Stockman Mine Response to EES

Victorian National Parks Association
2014

The tailings dam

SECTION A C119
SCALE 1:300
CLOSURE - TYPICAL SECTION

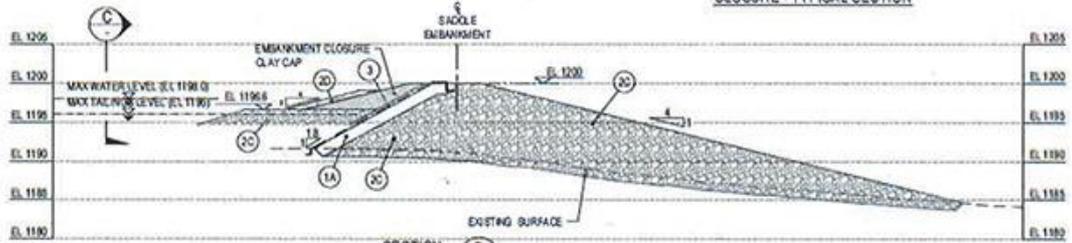
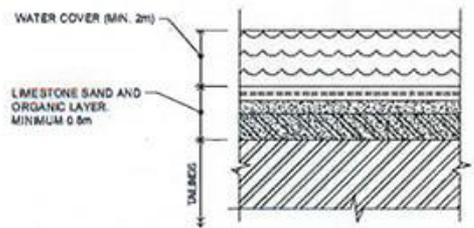
There is minimal information available about its structure, short and long-term viability and maintenance:

- Written descriptions in the EES (eg Appendix B3, section 3) are sketchy.
- Cross-section diagrams (without any details) are tucked away in Appendix A to Appendix B3.

SECTION A C119
SCALE 1:300
CLOSURE - TYPICAL SECTION

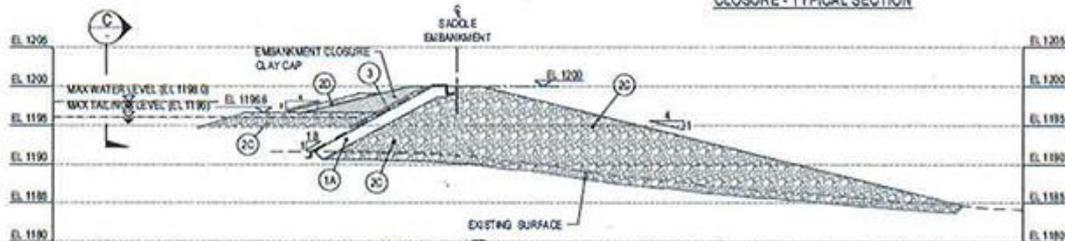
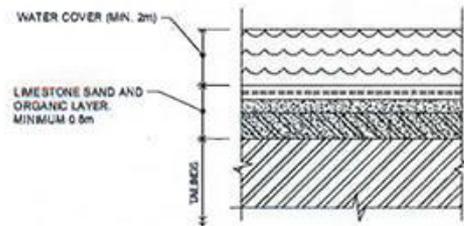
Climate change impacts: fire, flood, drought

1. Unlikely that the dam will have sufficient water cover during 10 year drought .
2. No mention of the siltation of the dam, following fire and flood (only an assessment that revegetation and erosion maintenance will be required after fire every 10 years).
